Our ref: 062001-06

**Re: Tallawarra B Power Station – Revised AC 139.E-02v1.0 implications to conditions of approval**

Figure 2 Runway 34 RNP Missed Approach surfaces

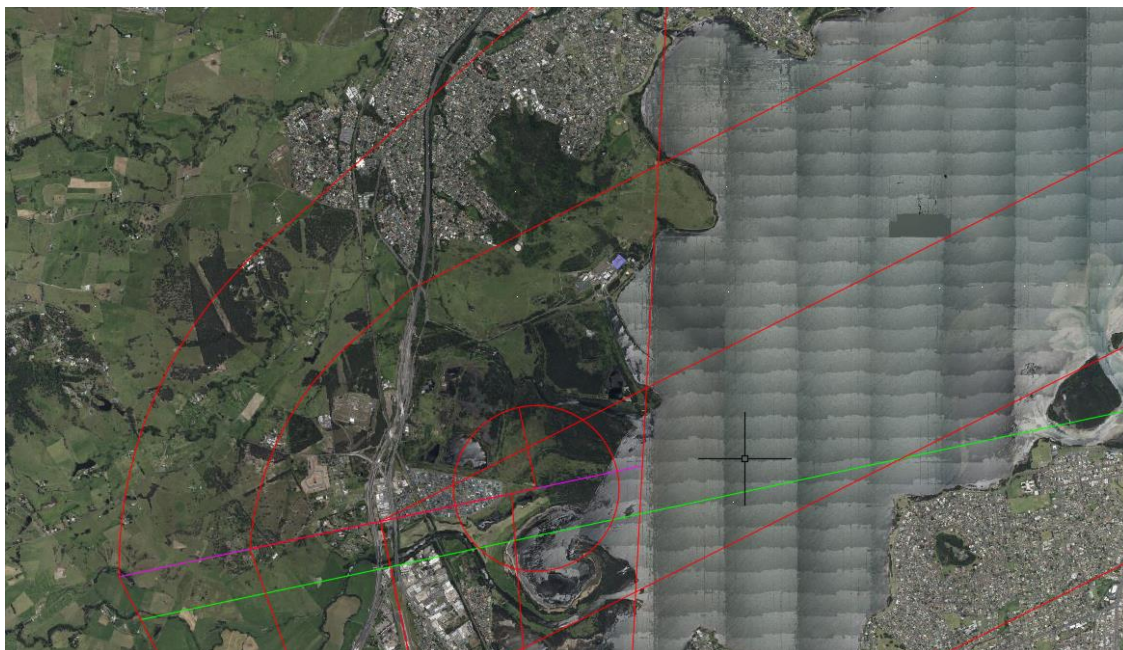
The limiting height for PANS-OPS surfaces over the site is determined by the missed approach for runway 34 RNP at 416.88 m AHD (1367.7 ft AMSL).

Images showing the associated surfaces are provided at Figure 2 and Figure 3.

According to the revised AC (paragraph 2.3.1) If there is an infringement of the PANS-OPS surfaces creating a probability of moderate turbulence greater than  $1 \times 10^{-5}$  per operation, CASA will take the position that the proposal will create an unacceptable risk to the safety of aircraft operations.

It goes on to say that if the proposal cannot be altered to avoid this impact, changes to Terminal Instrument Flight Procedures (TIFP) maybe an option. However, stakeholders such as LUPA, aircraft operators and airport operators must accept that any changes to TIFP will affect the regularity and efficiency of operations at the airport.
